**NOTICE OF A REGULAR MEETING
BONDURANT PLANNING AND ZONING COMMISSION
OCTOBER 12, 2023**

AGENDA

TITLE: Resolution considering recommended approval of Casey's Site Plan.

TITLE: Resolution considering recommended approval of Morgan Estates Plat 3 Preliminary Plat.

SHEET NUMBER:
C-003
2306.385

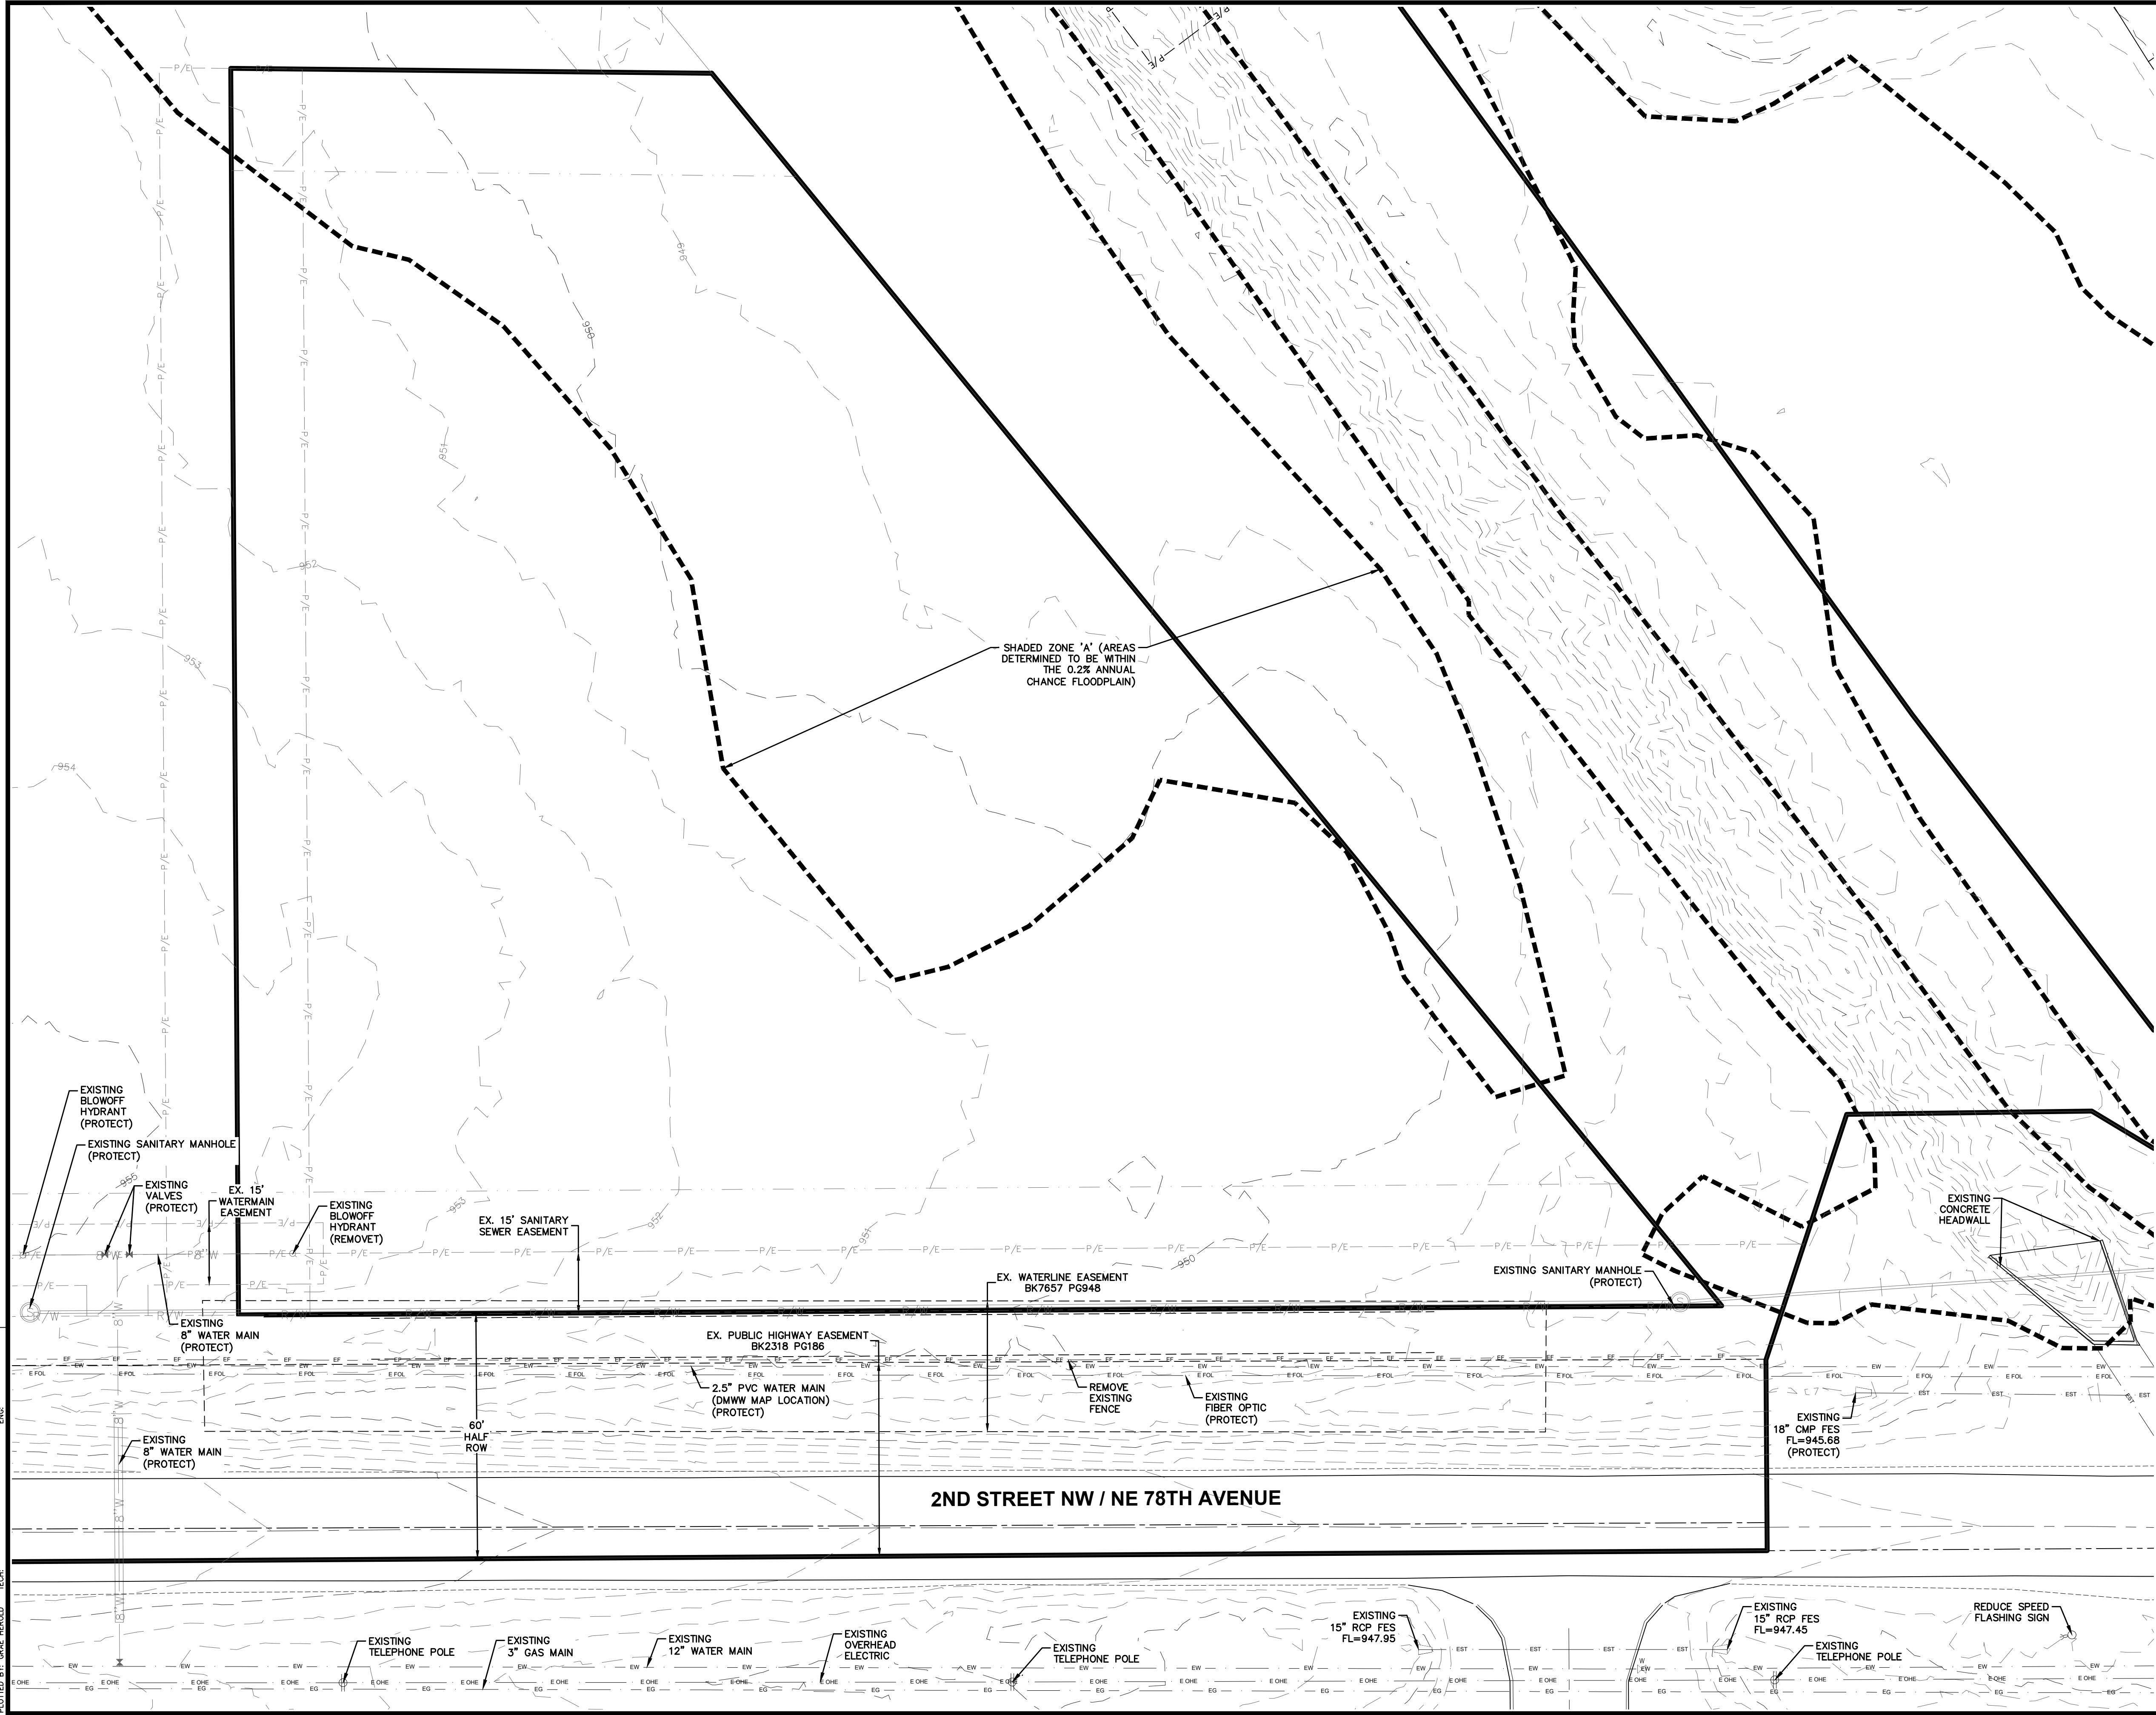
- The site plan labels the required setbacks at this location - a 30' front yard setback along 2nd Street NW, a 25' rear yard setback from their northern property line and no side yard setbacks from either the western or eastern property lines.
- The site plan shows a two underground fuel storage tanks.

- Access to the site is available from 2nd Street NW. The site plan shows two access points in the southeast and south west corners of the property. The access point in the southwest corner is a right-in/right-out only access point.

- The site plan shows that no part of any parking/drive area (excluding driveways) will be located closer than 3' away from the front property lines, as is required by Section 177.10.1.

- The site plan shows 31 parking spaces, including 1 handicap stall, and 1 loading spaces. 16 of the parking spaces are shown at the fuel receptors.
- The site plan shows parking spaces will be provided with raised curbing or equivalent, as is required by Section 177.10.8.

C4 - LAYOUT SHEET

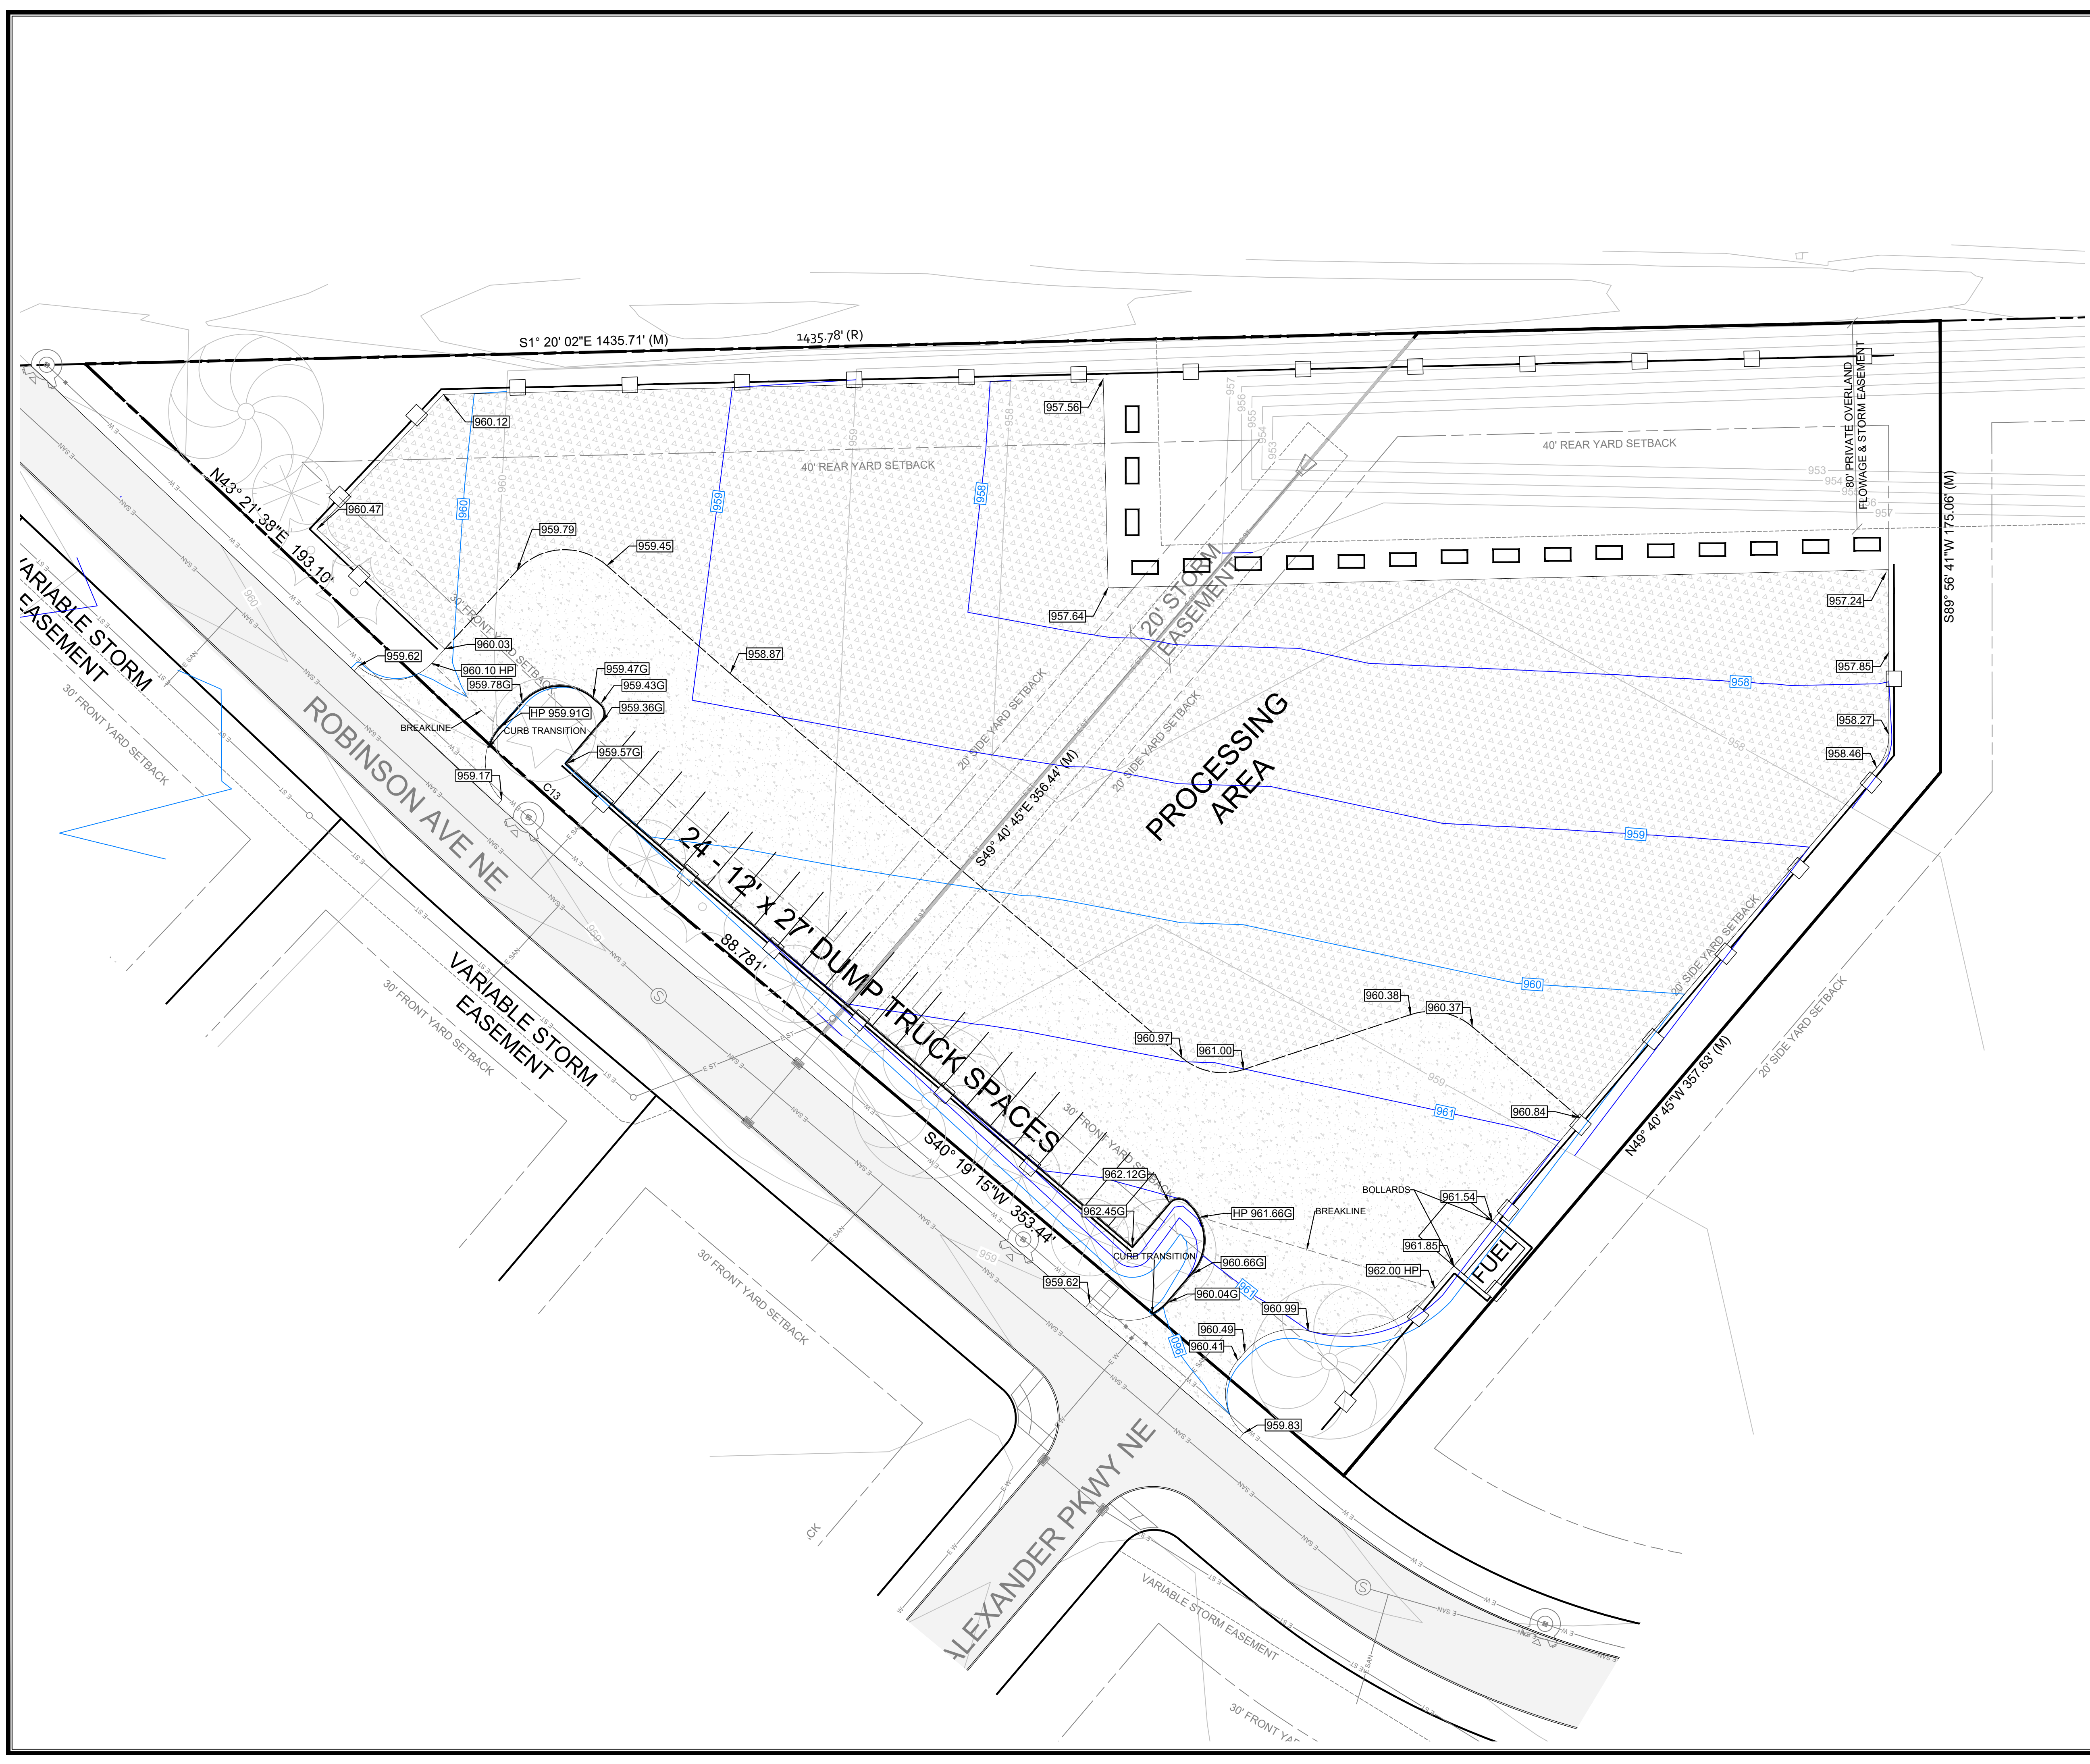
- Outdoor storage area is proposed for the majority of this site. This portion is not required to be paved as it was submitted prior to the adoption of new code requirements regarding outdoor storage surface requirements.
- The site plan labels the required setbacks at this location - a 30' front yard setback along Robinson Avenue NE, a 40' rear yard setback along the northern property line and 20' side yard setbacks along the eastern property line.

- Access to the site is available from Robinson Avenue NE.
- The parking lot will allow for 24 large truck stalls. The stalls are 12'x27' are the site plan notes they are intended for dump trucks.
- The site plan shows that no part of any parking/drive area (excluding driveways) will be located closer than 3' away from the front property lines, as is required by Section 177.10.1.
- The site plan shows that all parking/drive areas will be paved as required by Section 177.10.2 of the Zoning Code.
- The site plan notes there is one parking stall per employee.
- The site plan shows 24 parking spaces
- The site plan shows parking spaces will be provided with raised curbing or equivalent, as is required by Section 177.10.8.

2019 Approved PUD Conceptual Plan - 130 townhome units in Area D:

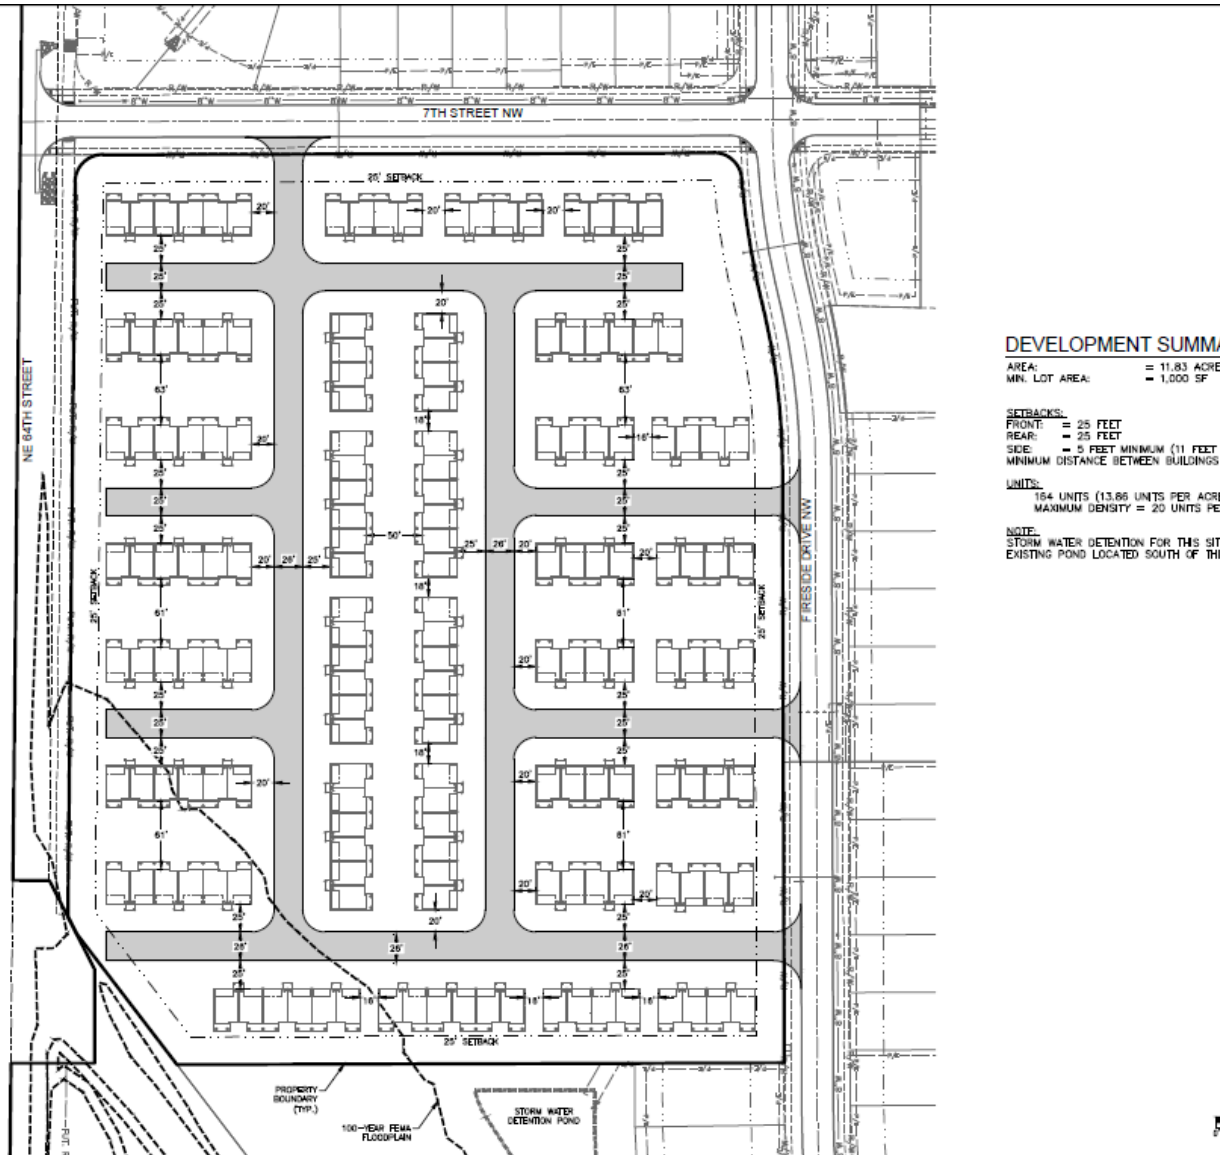
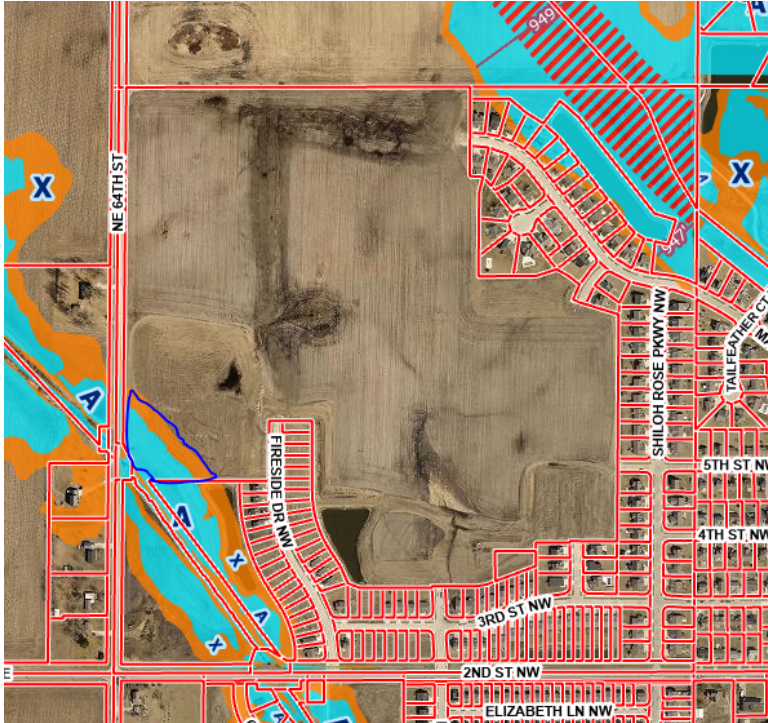
The 100-year floodplain makes up the southwest portion of Area D. The 2023 draft layout proposes the developer will elevate the southwest corner out of the 100-year floodplain so it is considered buildable - this elevation allows for 14 townhome units to be constructed within the boundaries of the current 100-year floodplain area. Along with this potential change in floodplain elevation, the developer is also proposing a reconfiguration of the townhome area layout so that an additional 20 units outside of the current 100-year floodplain can also be constructed.

Should the developer pursue a substantial modification to their 2019-approved Harvest Meadows PUD Conceptual Plan, this substantial modification will be reviewed in the same manner that a rezoning is reviewed, meaning that neighbors within 200' of the impacted parcel ([Parcel 231/00001-000-973](#)) are notified, the Planning & Zoning Commission holds a public hearing, City Council holds a public hearing, and then City Council considers an ordinance.
